RHODE ISLAND DEPARTMENT OF TRANSPORTATION

I-195 Relocation – Contract 16 – Providence River Pedestrian Bridge

NOTICE TO PROSPECTIVE BIDDERS

ADDENDUM NO. 8 Prospective bidders and all concerned are hereby notified of the following changes in the Plans, Specifications, Proposal and Distribution of Quantities for this contract. These changes shall be incorporated in the Plans, Specifications, Proposal and Distribution of Quantities, and shall become an integral part of the Contract Documents.

CONTRACT 16 VOLUME 2

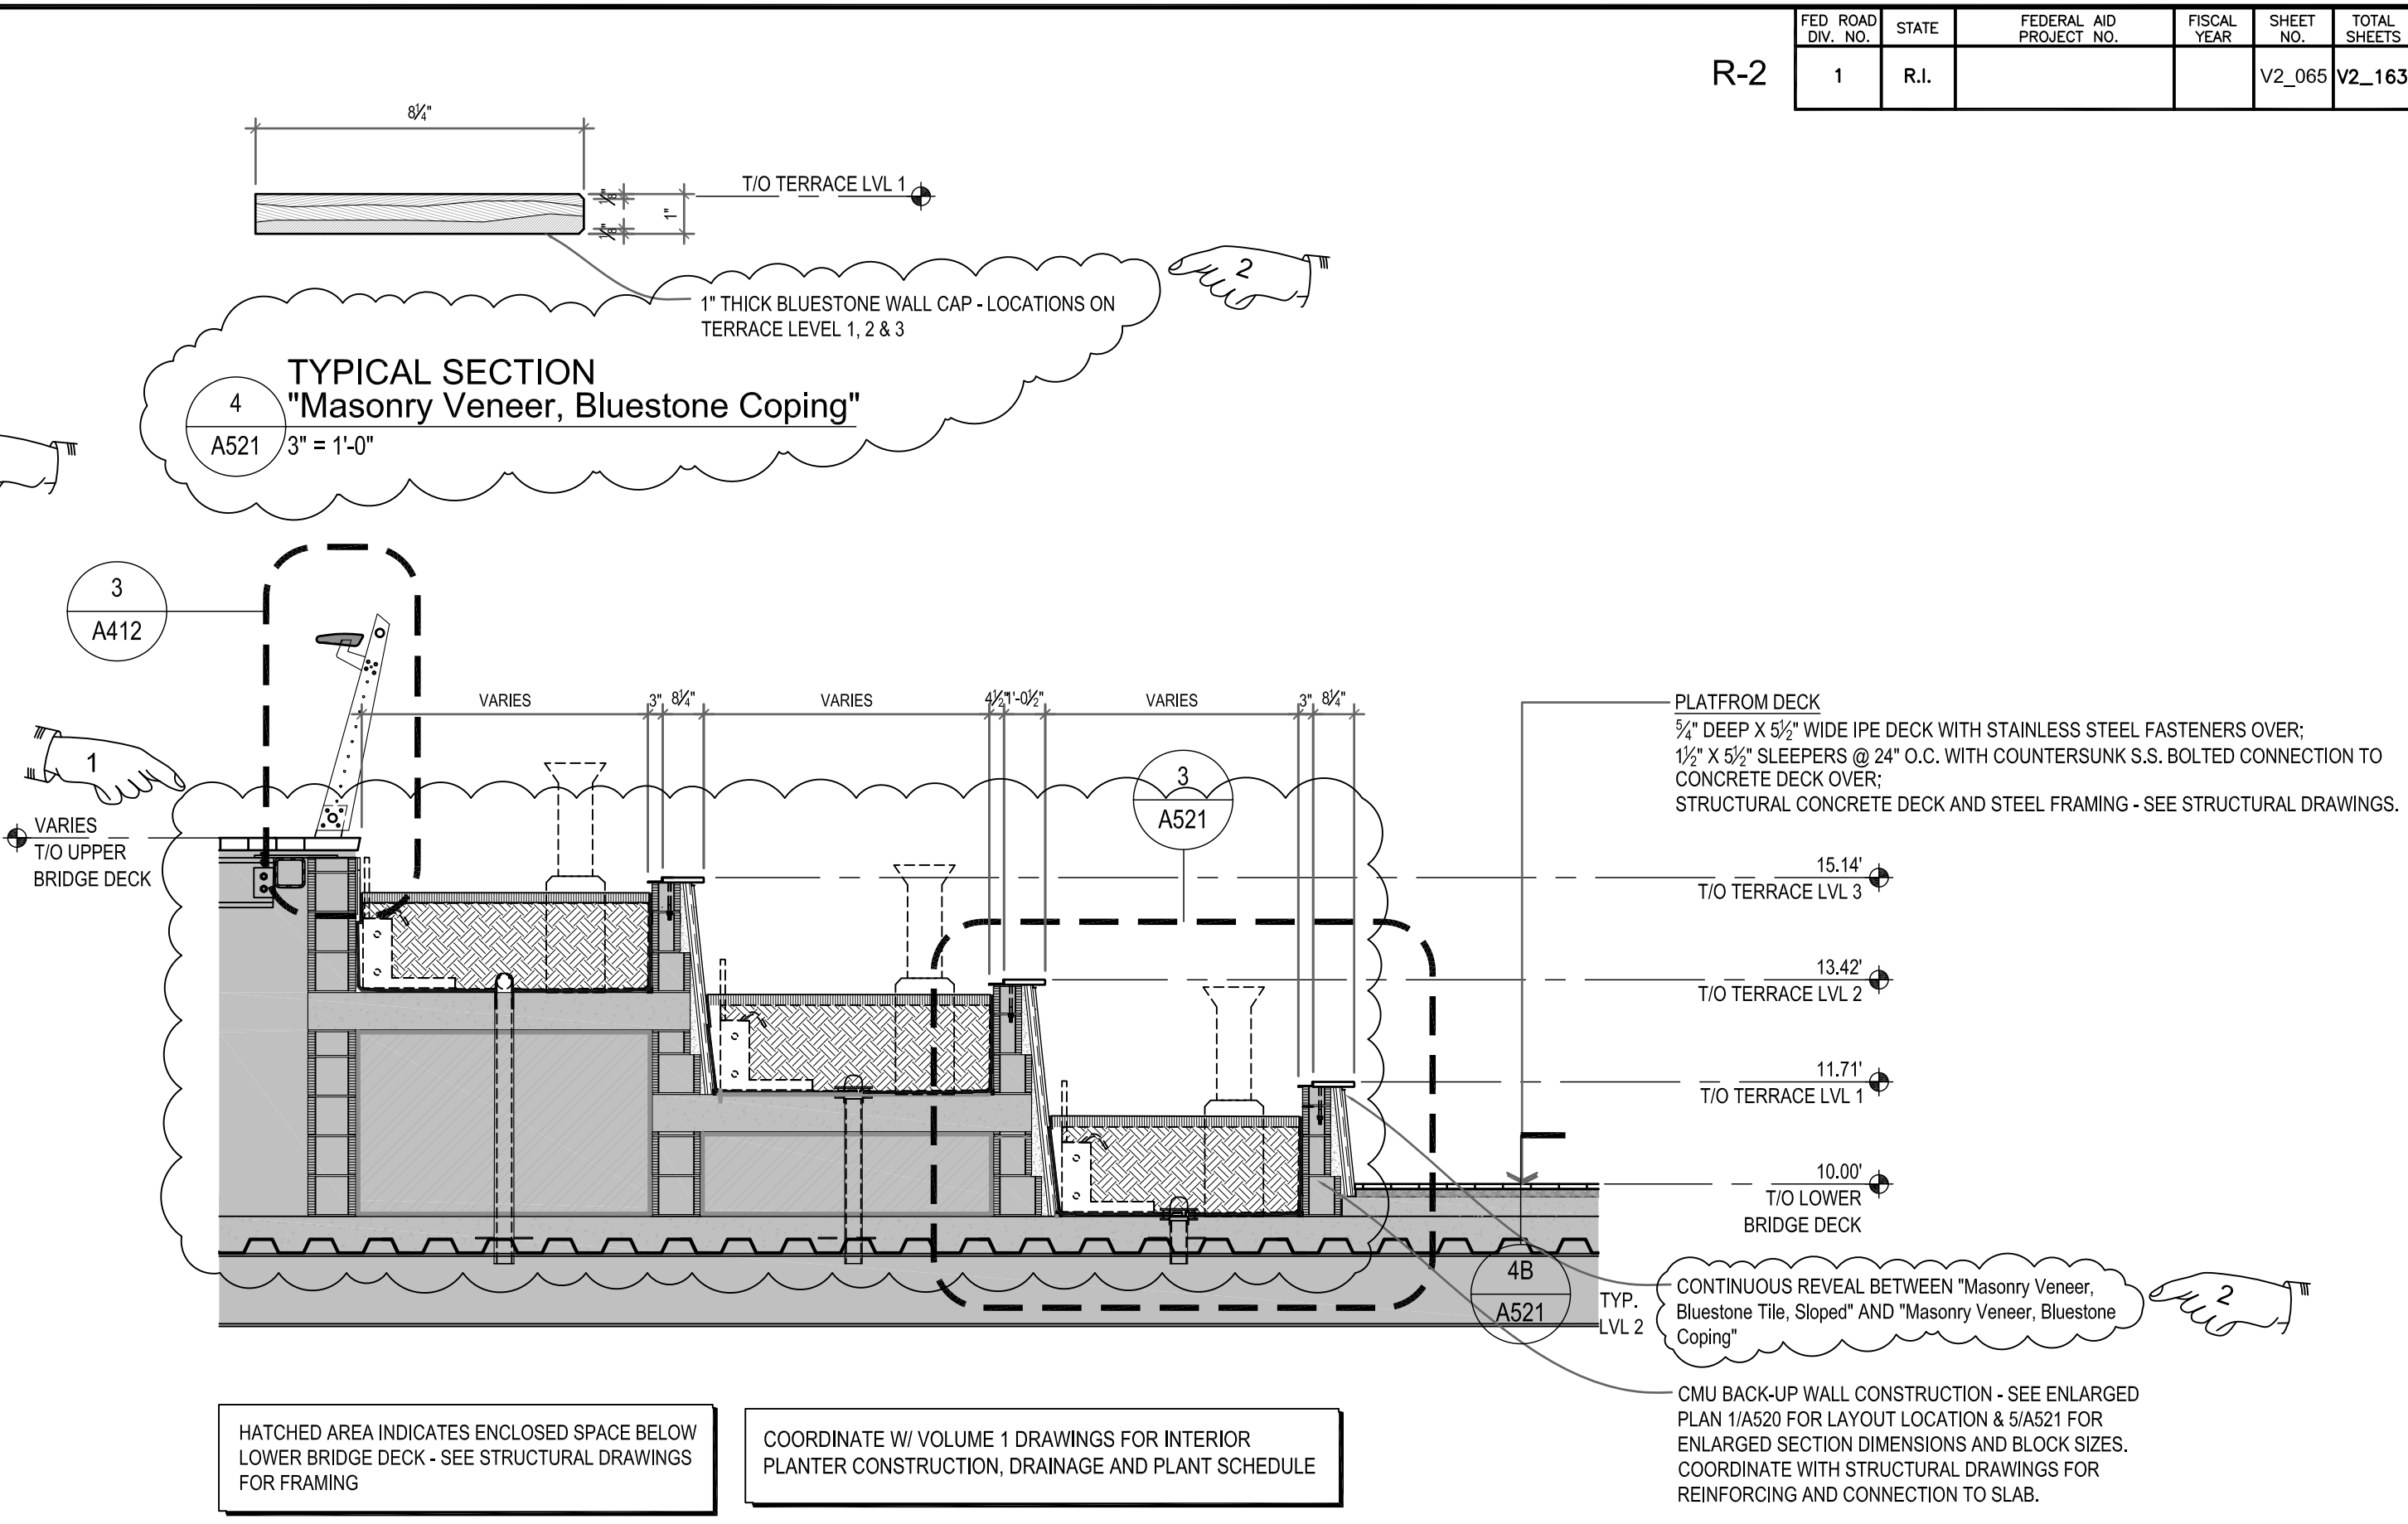
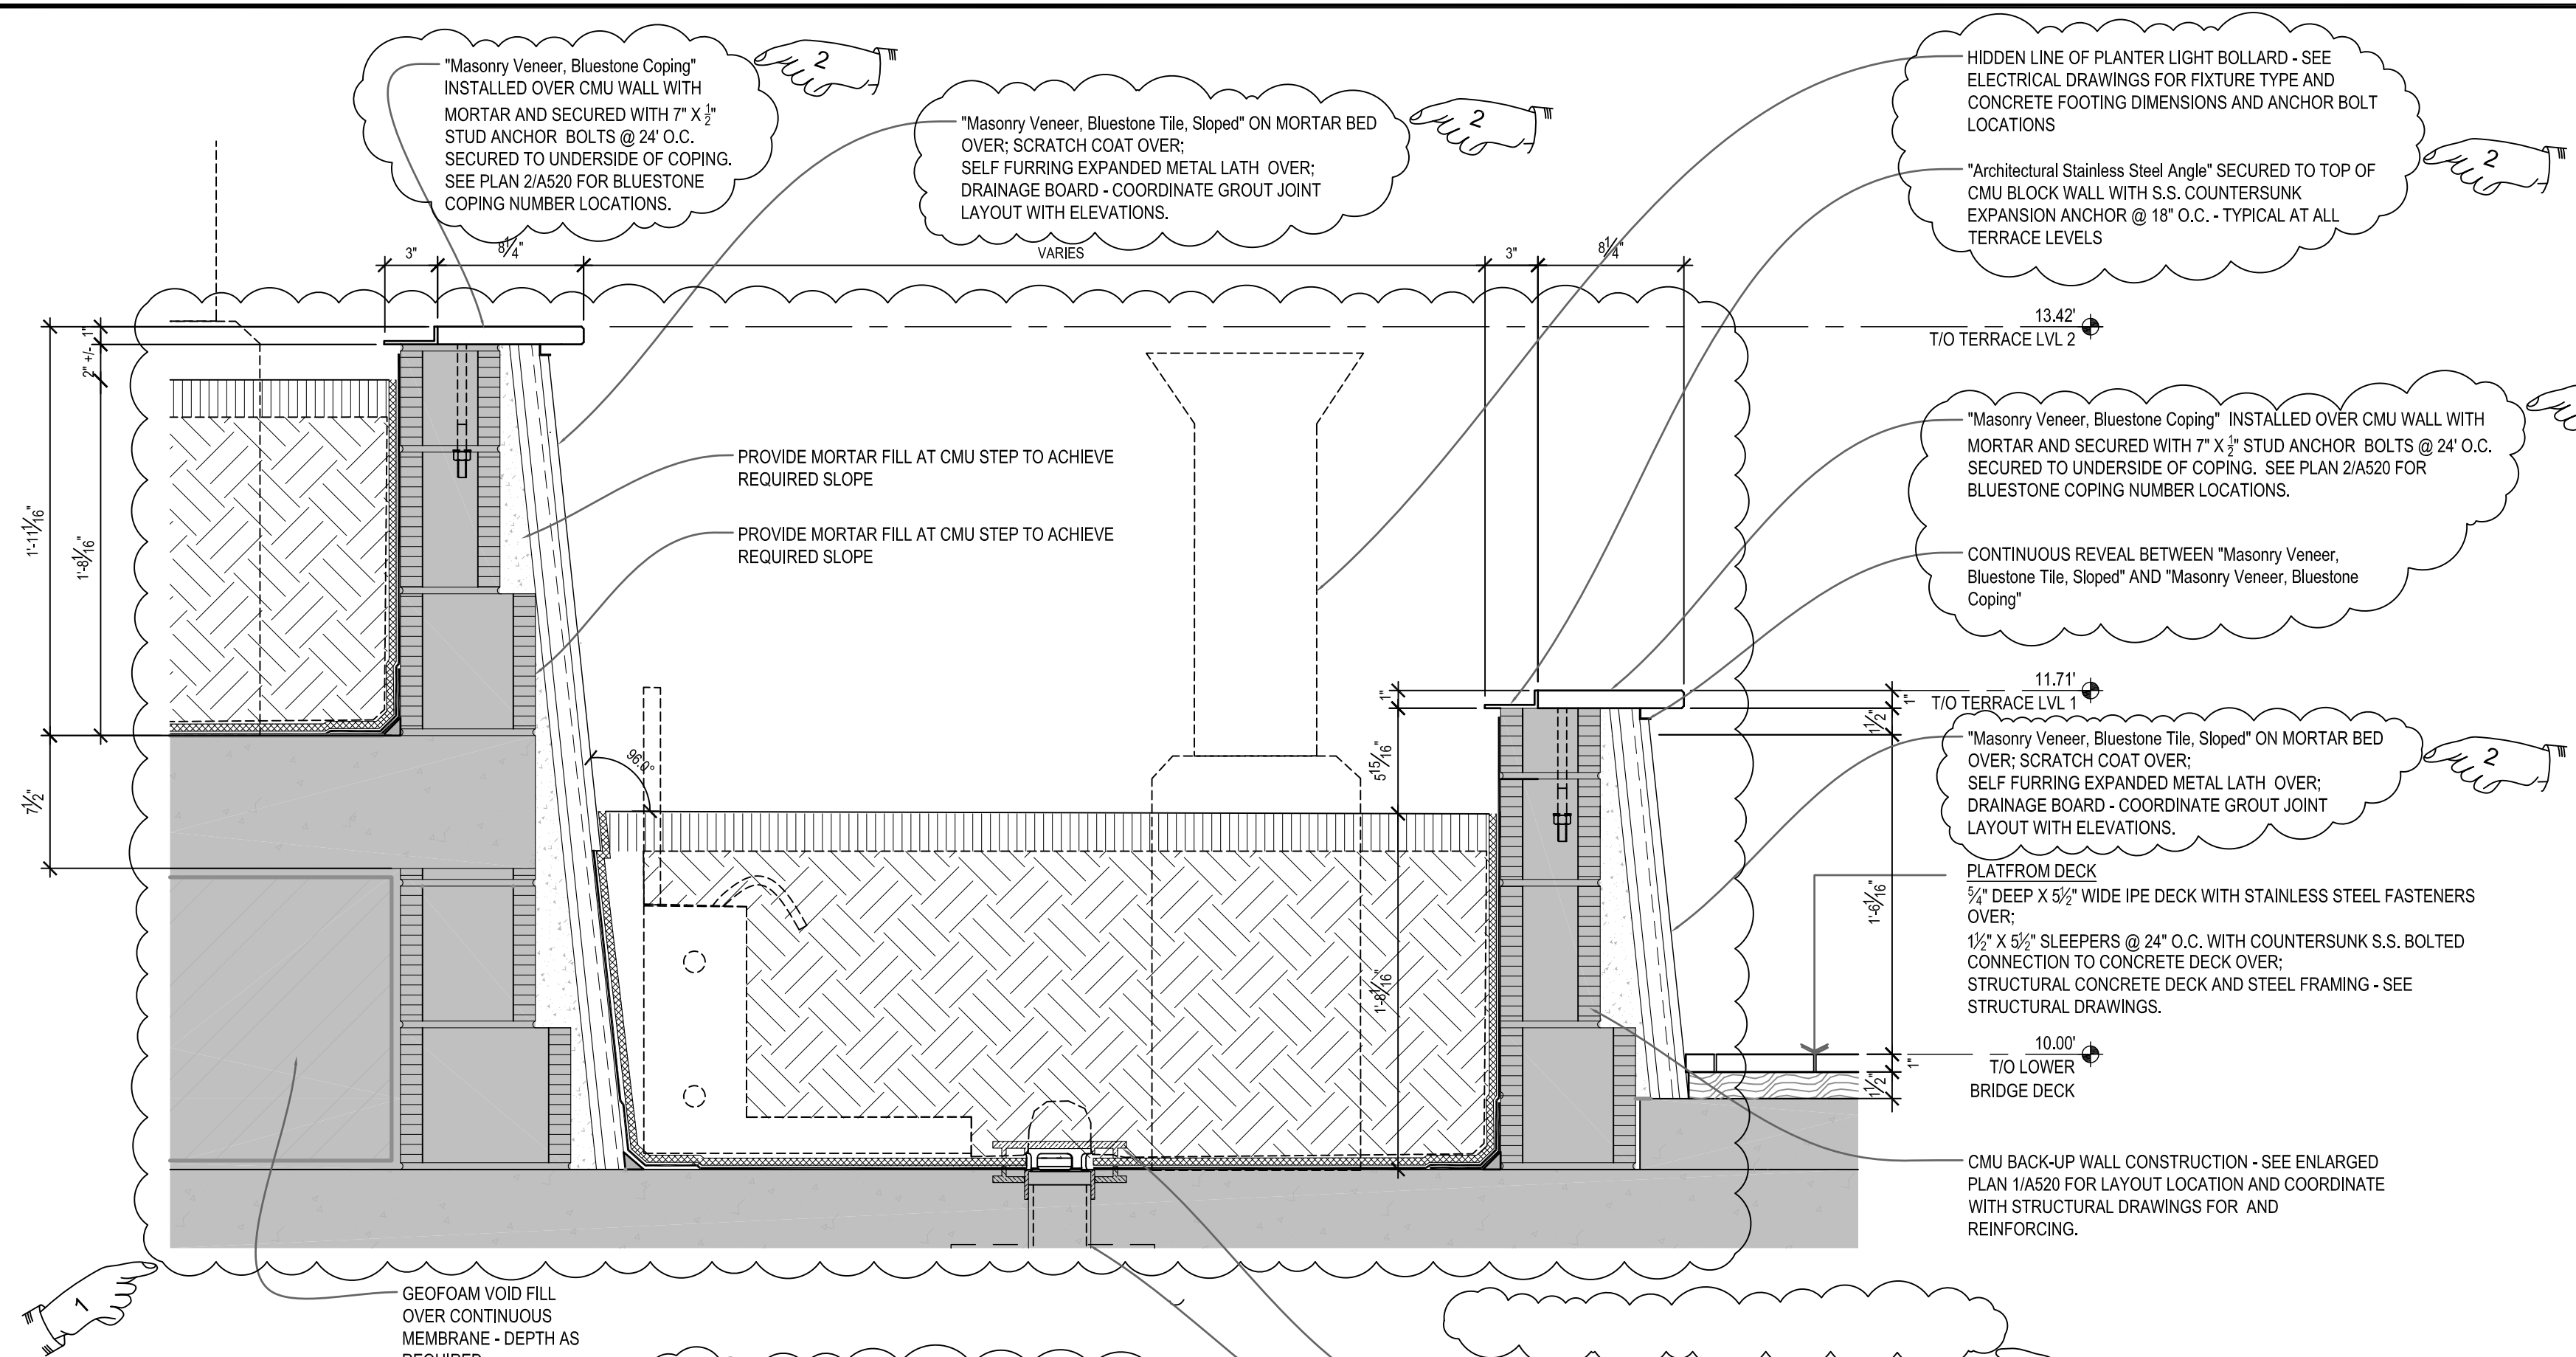
Delete Sheet V2_064(R-1) in its entirety and replace it with sheet V2_064(R-2) attached to this Addendum No. 8. Callouts for the railing details have been revised.

DESIGNED BY: AN	SCALE: NTS
CHECKED: CDL	
DATE: 04/21/14	
SHEET: V2_072	
OF: V2_163

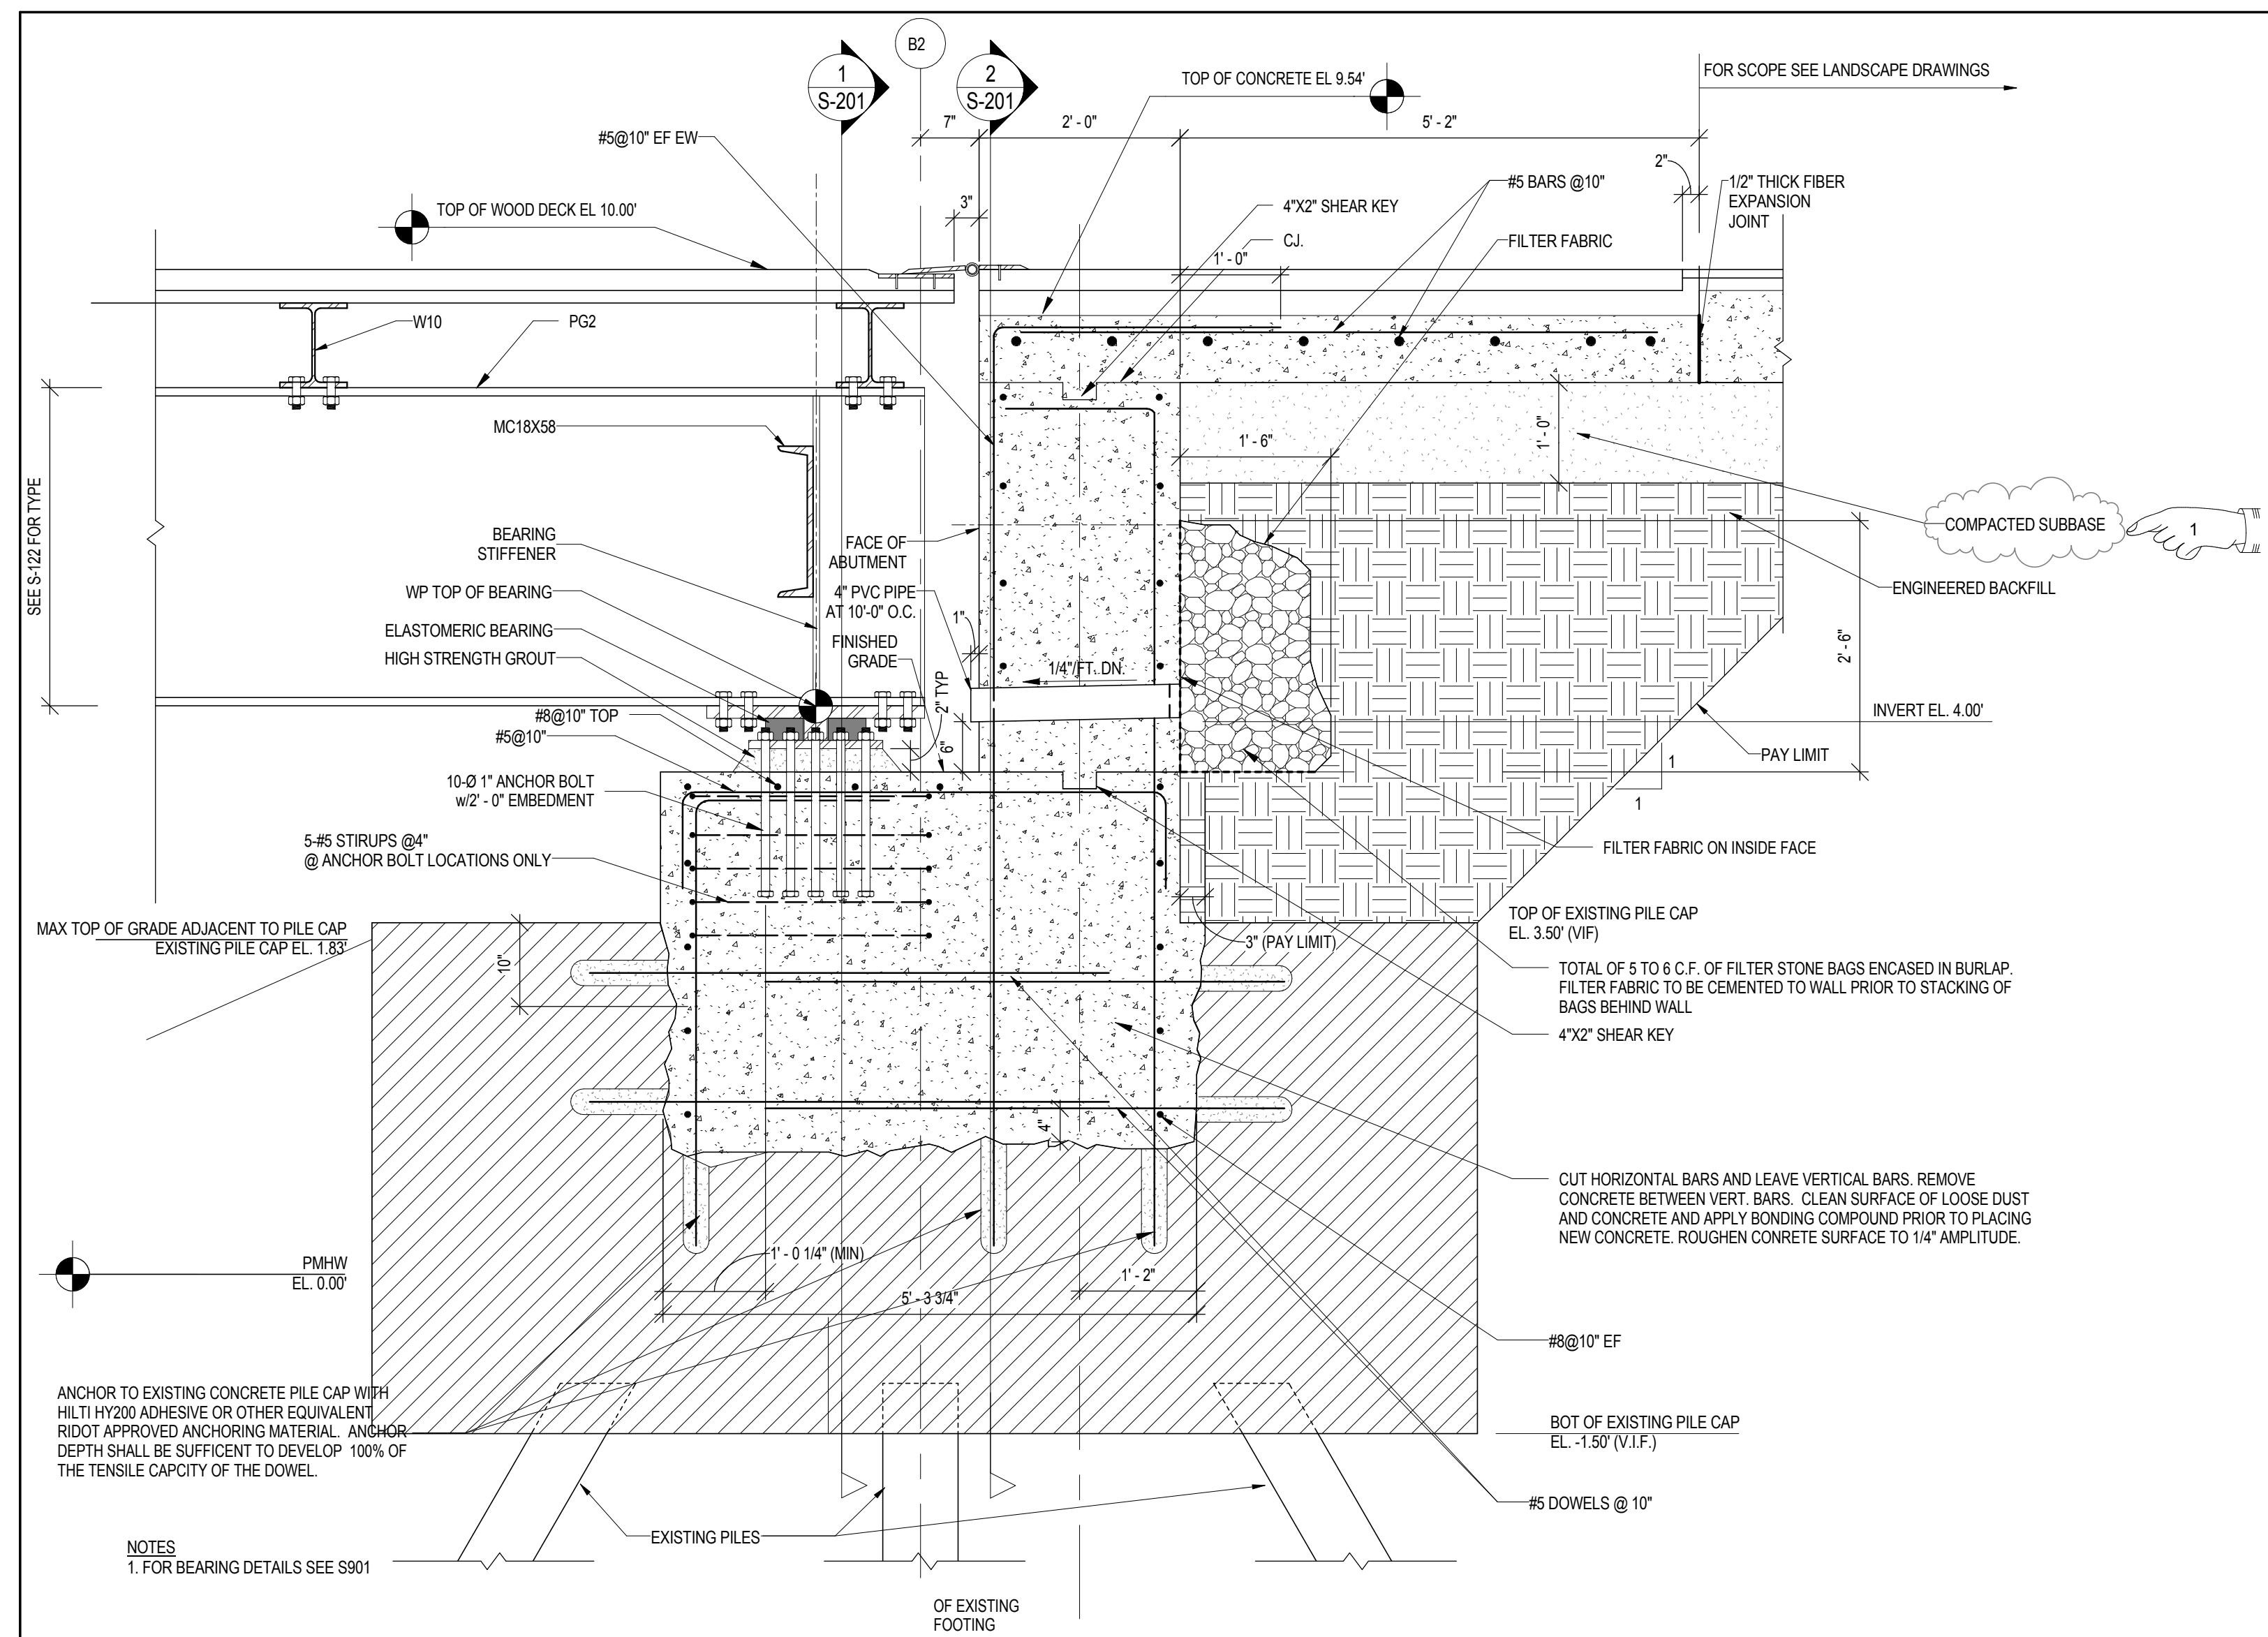
Delete Sheet V2_072(R-1) in its entirety and replace it with sheet V2_072(R-2) attached to this Addendum No. 8. Notes have been deleted. A note has been revised.
